Access Compliance Report

Public Rights-of-Way

(Curb Ramps)

Intersection ID: 50042	Main Street: BAXTER_ST	Cross Street: S_KINGS_DR	Location: SE
ADA ID: 7CF33DD9A6B8	Ramp Type: Perp	Initial Pass/Fail: Fail	Overall Compliance: No
Severity Score: 33.75			
Codes/Mitigation Info/Possible Solution		Field Measurements/Component Compliance

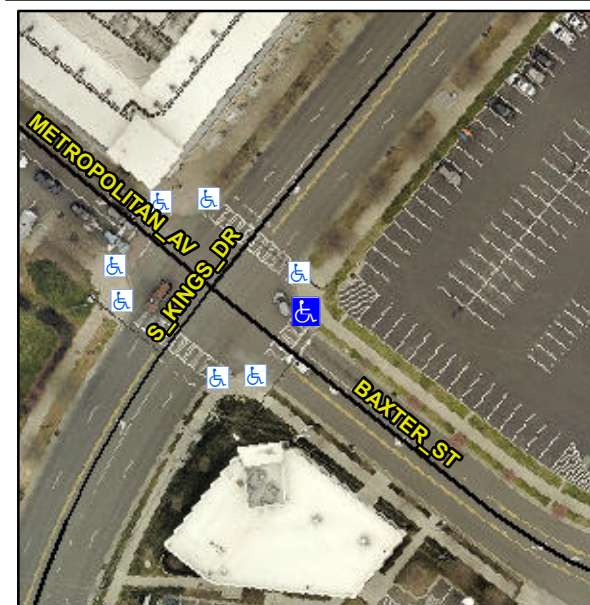
R304.5.1, R304.5.3

Compliance	Description	Data	Compliance	Description	Data
N/A	Ramp Length (in)	133.0	Yes	Ramp Slope (%)	7.1
No	Ramp Width (in)	47.0	No	Ramp XSlope (%)	8.0
N/A	Flare Type LT	N/A	N/A	Flare Type RT	N/A
N/A	Flare Slope LT (%)	N/A	N/A	Flare Slope RT (%)	N/A
N/A	Flare Traversable LT?	N/A	N/A	Flare Traversable RT?	N/A
N/A	Landing Length (in)	N/A	N/A	DWS Provided?	N/A
N/A	Landing Width (in)	N/A	N/A	DWS Contrast?	N/A
N/A	Landing Slope (%)	N/A	N/A	DWS Length (in)	N/A
N/A	Landing X Slope (%)	N/A	N/A	DWS Full Width?	N/A
N/A	Landing Curb? (Y/N)	N/A	N/A	DWS Offset (in)	N/A
N/A	Shared Landing?	N/A			
N/A	Gutter Ponding?	N/A	N/A	Gutter Slope (%)	N/A
N/A	Gutter Lip Ht (in)	N/A	N/A	Gutter X Slope (%)	N/A
N/A	Painted X Walk1?	Yes	N/A	Painted X Walk2?	N/A
	X Walk 1 Direction	To SW		X Walk 2 Direction	N/A
N/A	X Walk 1 Width (in)	104.0	N/A	X Walk 2 Width (in)	N/A
	X Walk 1 Slope (%)	0.9		X Walk 2 Slope (%)	N/A
	X Walk 1 X Slope (%)	4.8		X Walk 2 X Slope (%)	N/A

Remove & Replace Entire Ramp.
